PROJ. NO.: G25003-01
SUBJECT: Addendum No. 2
Court Renovation
City of Fort Oglethorpe, Georgia

**ADDENDUM NO. 2
COURTS RENOVATION
CITY OF FORT OGLETHORPE, GEORGIA
CTI PROJECT NO. G25003-01**

Fort Oglethorpe Courts Renovation

Courts Finish Plan

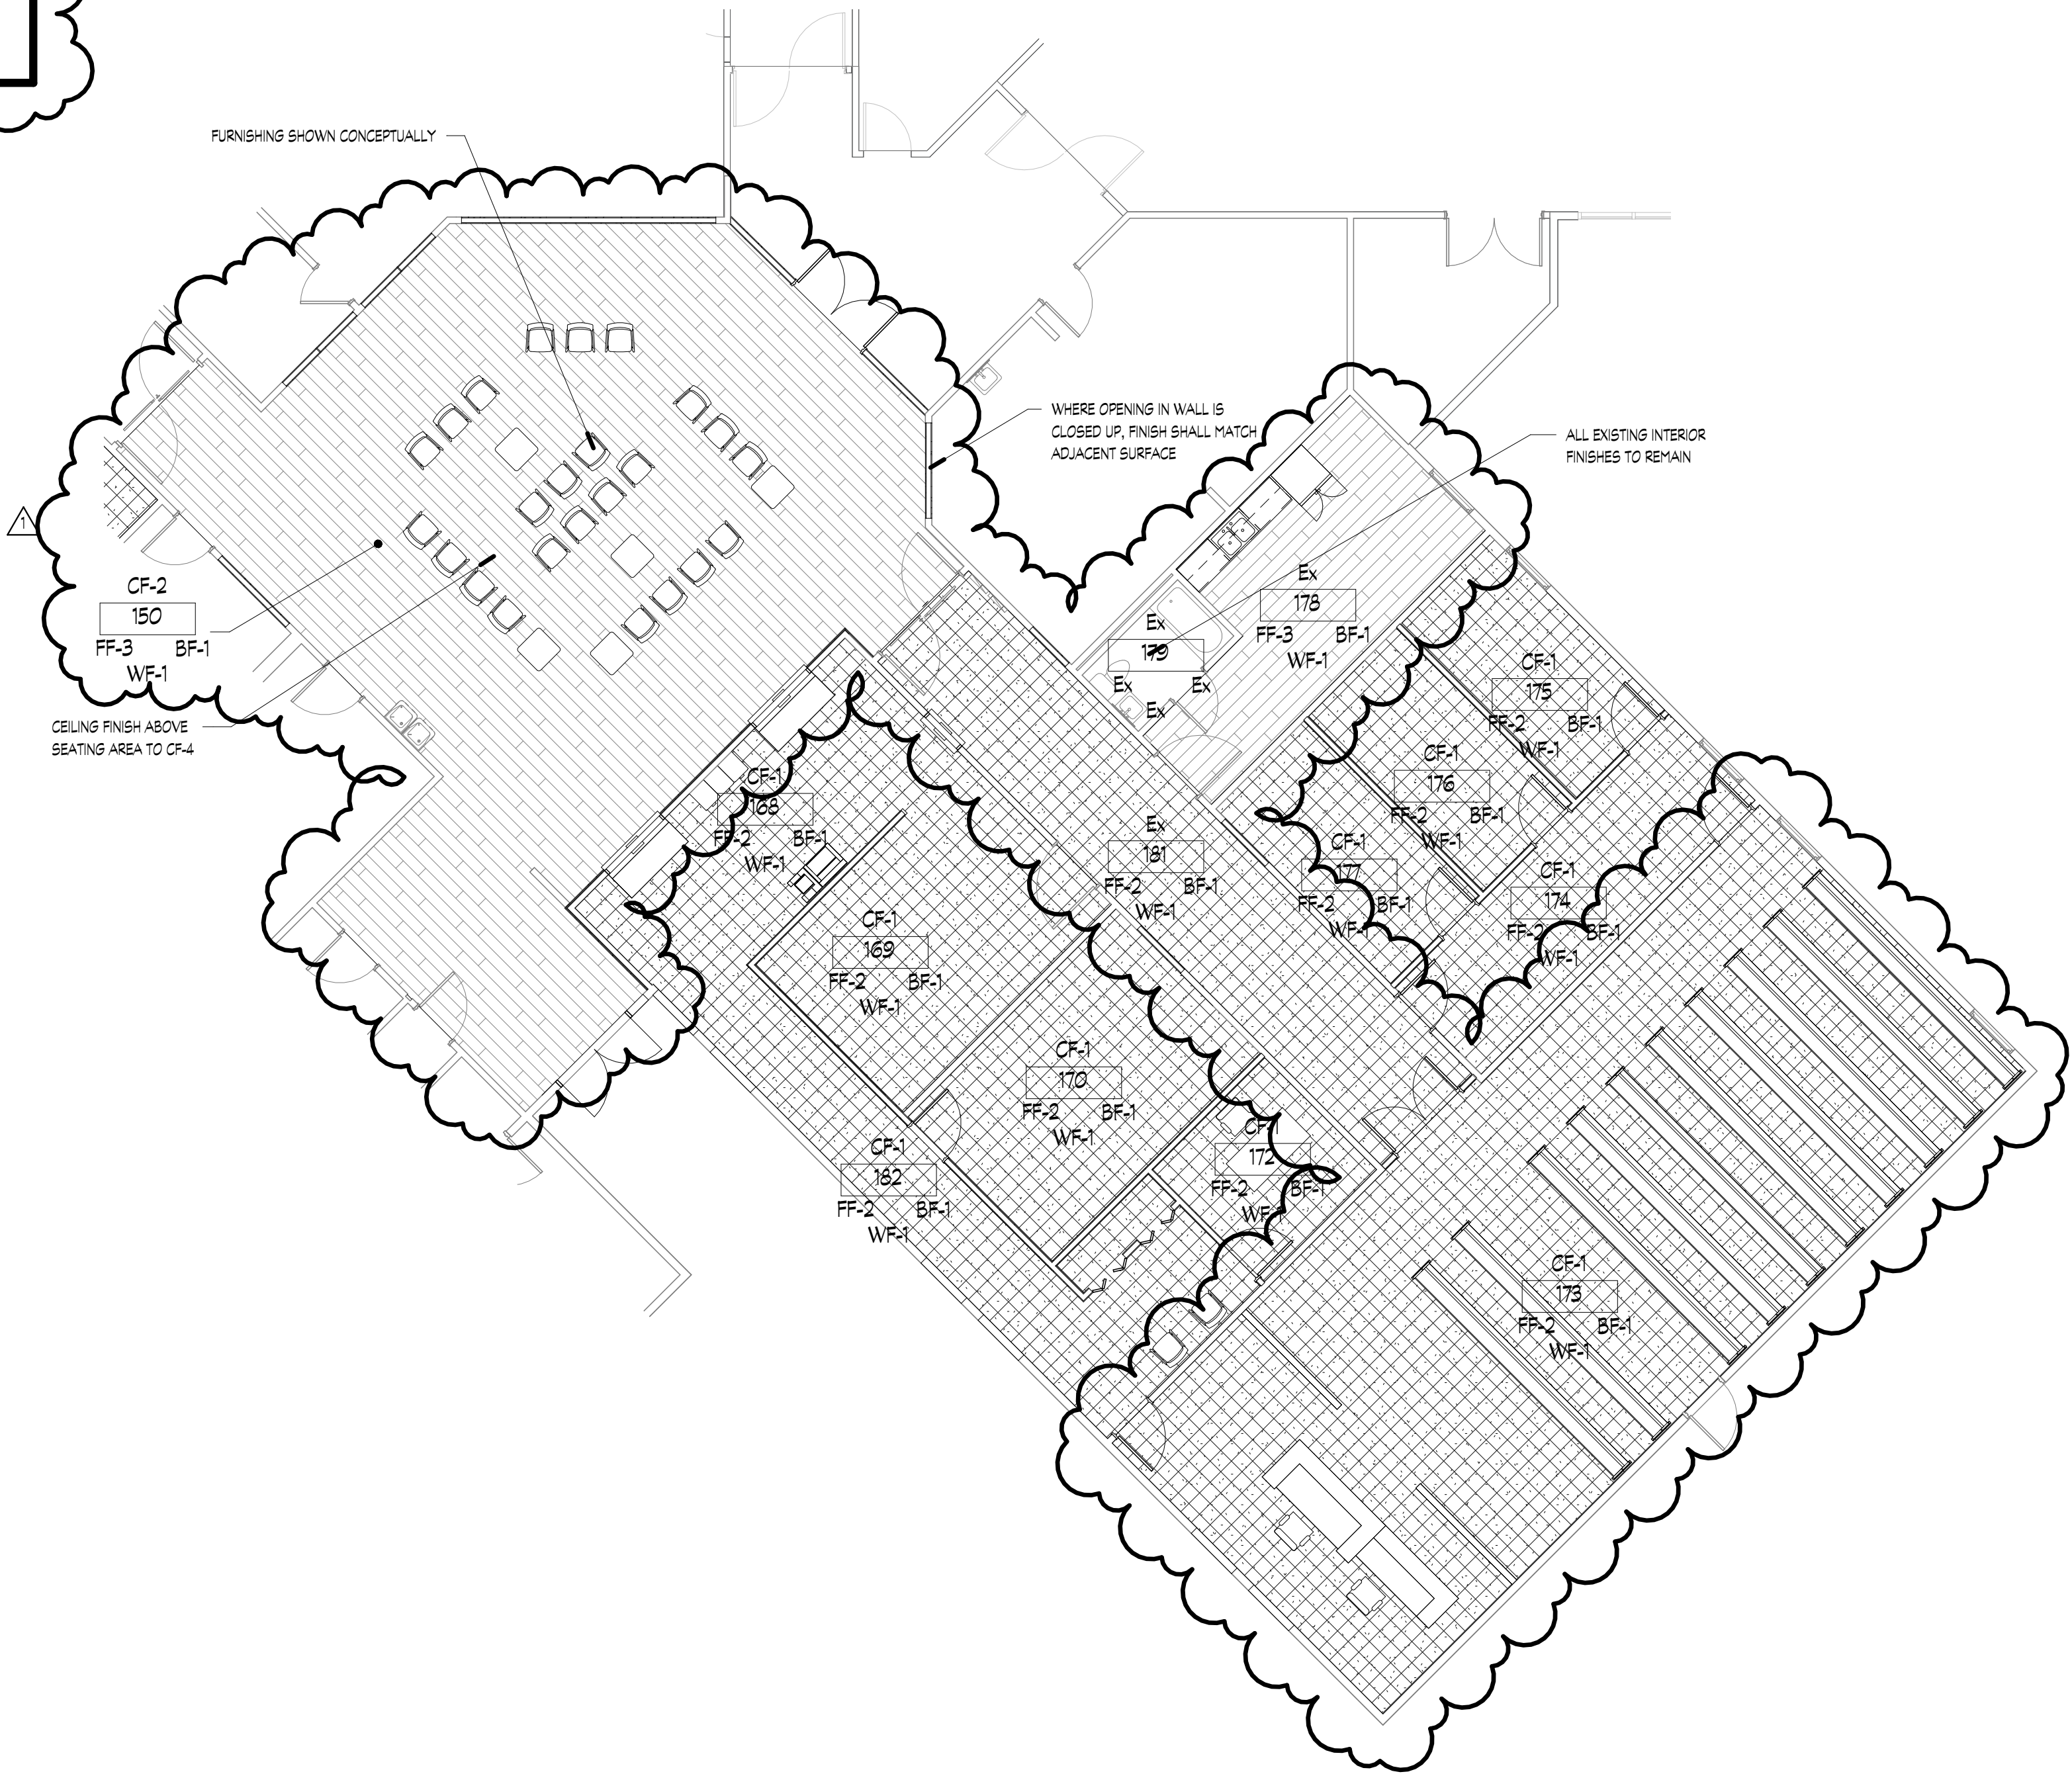
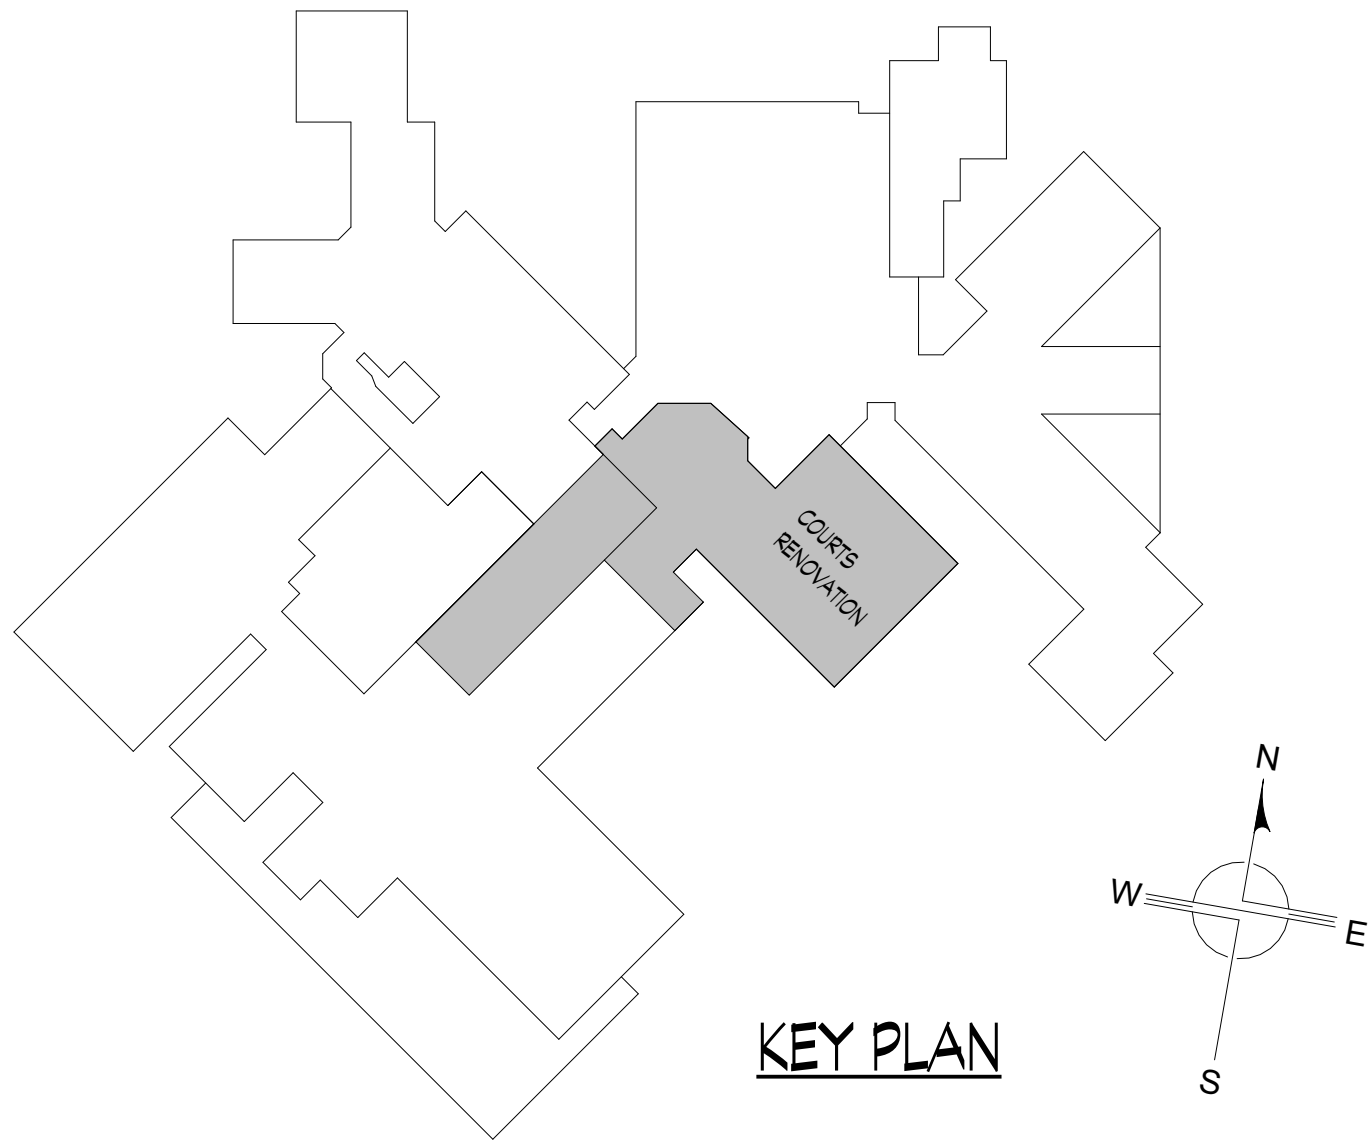
Revision Schedule		
Rev. #	Rev. Date	Revision Description
1	07/24/25	Door Change
